Access Compliance Report Public Rights-of-Way (RR Crossings)

Intersection ID: 53713	Main Street: N_TRYON_ST	Location: N/A
ADA ID: 99E9ABF3BB6B	Overall Compliance: No	Severity Score: 0.0
Codes/Mitigation Info/Possible Solution		Field Measurements/Component Compliance

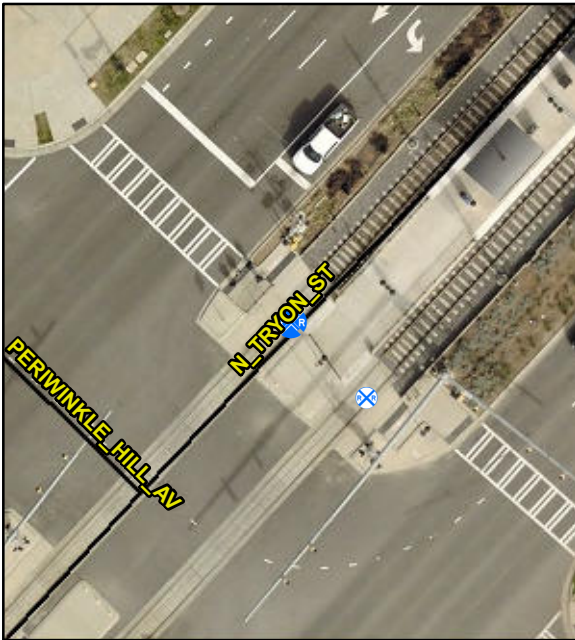
Remove & Replace Detectable Warning System. Provide Pedestrian Gate. Remove & Replace Walking Surface Adjacent to Rail.

Compliance	Description	Data
Yes	DWS Provided?	Yes
Yes	DWS Contrast?	Yes
Yes	DWS Width (in)	Yes
Yes	DWS Length (in)	24.0
No	DWS Offset (in)	65.5
No	Pedestrian Gate?	No
N/A	DWS Outside Gate?	No
N/A	Rail Type?	LightRail
No	Flangeway Gap (in)	2.5
Yes	Sidewalk Width (in)	121.0
